Re: Glacier Ridge Wind Farm Application for Certificate of Site Compatibility
Case No. PU-16-539

Re: Glacier Ridge Project: Barnes County, ND

Glacier Ridge Wind Project – Impact Analysis NOTIFICATION OF CHANGES REQUESTED

Fargo/Grand Forks WSR-88D Impacts Summary and Desired Action

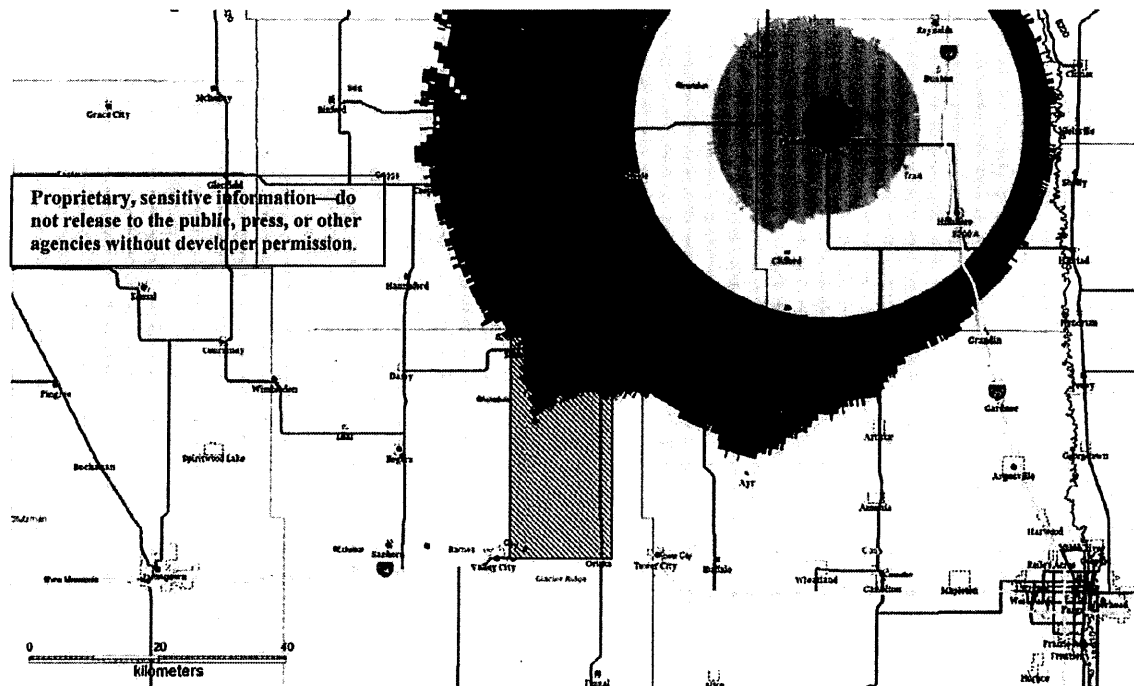
A portion of the proposed Glacier Ridge Wind Energy Project would be in the Fargo/Grand Forks WSR-88D radar's line of sight (RLOS) and would routinely cause clutter in the radar data. Approximately 29% of the project area is within the radar's designated Notification Zone (olive-green area in Fig 1).

However, due to the distance from the radar, impacts to radar data should be low and confined to the wind farm area. The Radar Operations Center would like to track the project to completion and reanalyze it if significant changes are made. Please notify the Radar Operations Center of significant project changes via email at wind.energy.matters@noaa.gov.

Figure 2: Close up of the northern portion of the proposed Glacier Ridge wind project area (blue rectangle). The black-shaded area indicates where 150-m turbines would penetrate the radar line-of-sight.

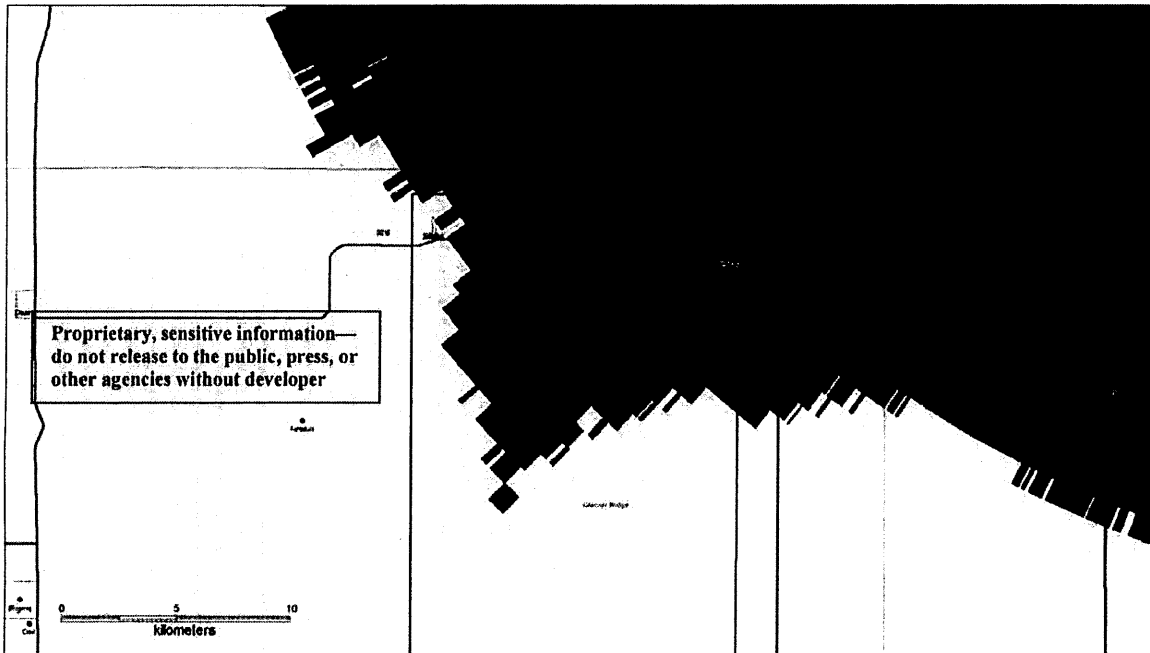
The proposed project would install an unknown number of wind turbine generators, each with a maximum blade-tip height AGL of 150 meters, in a 585 sq km area as close as 46.8 km southwest of the Fargo/ Grand Forks, ND WSR-88D. Beam propagation analysis indicates that 150-m turbines placed in 29% of the area (northern portion) would protrude into the radar beam, up to 7% of the beam width, during the 1st elevation scan angle (0.5 deg), under standard atmospheric conditions. Wind turbines placed in this portion of the project area would be frequently visible in the radar data in radar azimuths 218-236° (SW). Due to distance (> 20 km), multipath scattering down-range from the wind farm is not expected to occur. Data impacts should be confined to the portion of the wind farm area in the RLOS. Mitigation is not necessary (see Fig 2).

- NOAA will not request mitigation for this project configuration.
- NOAA requests to be notified of any significant changes to the wind energy project, such as raising the turbine heights by more than 10 meters, or if the project boundaries change.
